1532 SW MORRISON ST.

Project: 56623 - Allied Works Remodel

Submittal No.: 10100-03 -- Access Floor (Deferred)

HAWORTH ACCESS FLOOR

Steel Stringer with Gasket - 2" and 4"

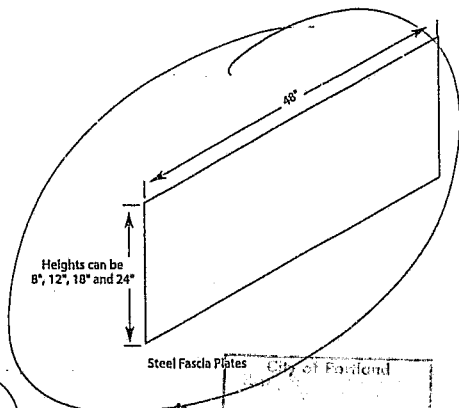
COORDINATE HEIGHT TO
ALLOW FOR MECHANICAL
UNIT CLEARANCES & UNISURUT
SUPPORTS WHERE REQUIRED

TecCreate Panel Ramp (components shown on next page)

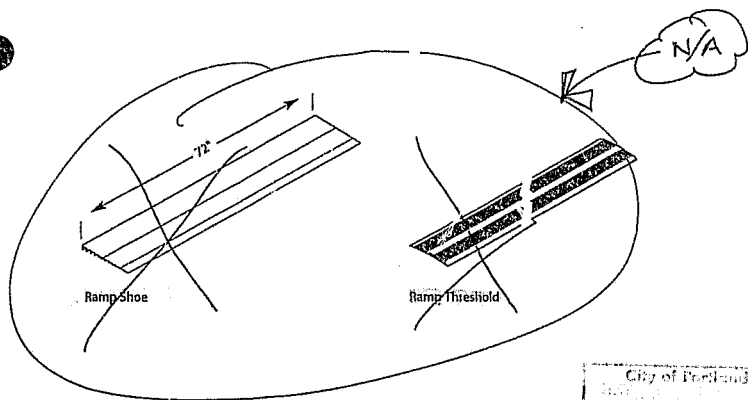
SUBMIT FOR REVIEW AS PERTAINS TO DETAIL (2) ON HAWORTH ACCESS FLOOR PLAN DIAGRAM

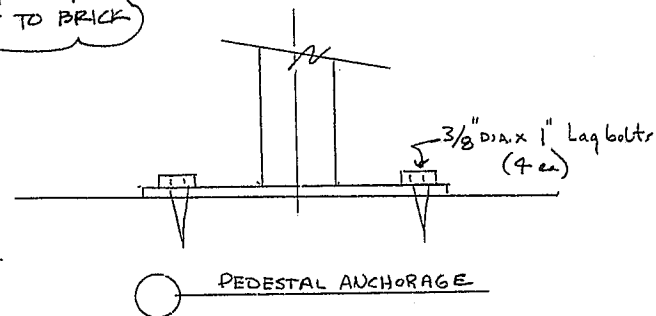
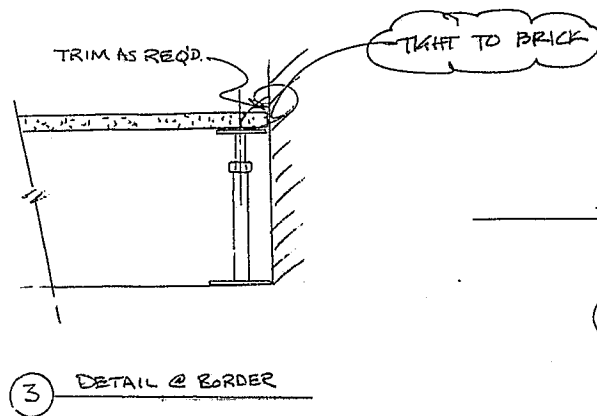
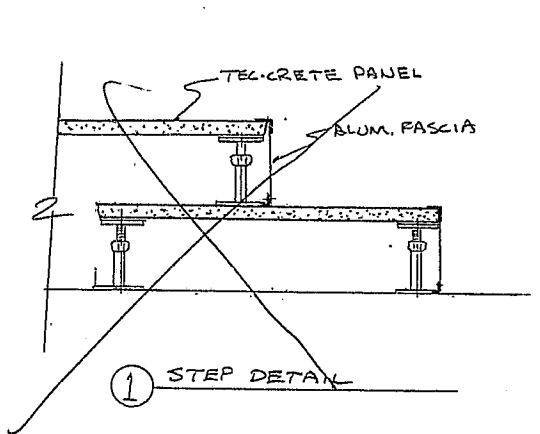
SUBMIT PROPOSED TRIM ANGLE FOR REVIEW

HAWORTH ACCESS FLOOR.
ALLIED WORKS ARCHITECTURE.

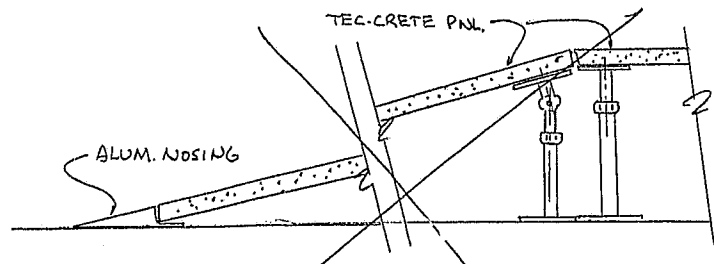
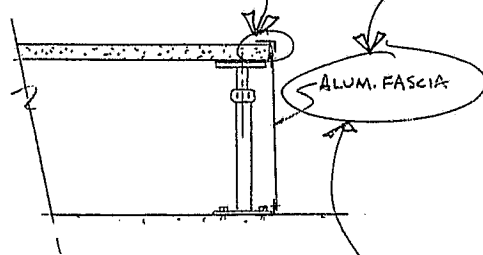
SUBMIT ALUMINUM & STEEL SAMPLES FOR REVIEW

COORDINATE W/ ARCHITECT'S DETAIL & MATERIAL SELECTION. MATERIAL TO ALLOW FOR REQUIRED RETURN AIR TO UNDER-FLOOR UNIT.

② FIN. REFERS TO TRIM ANGLE @ PANEL EDGE / TRANSITION
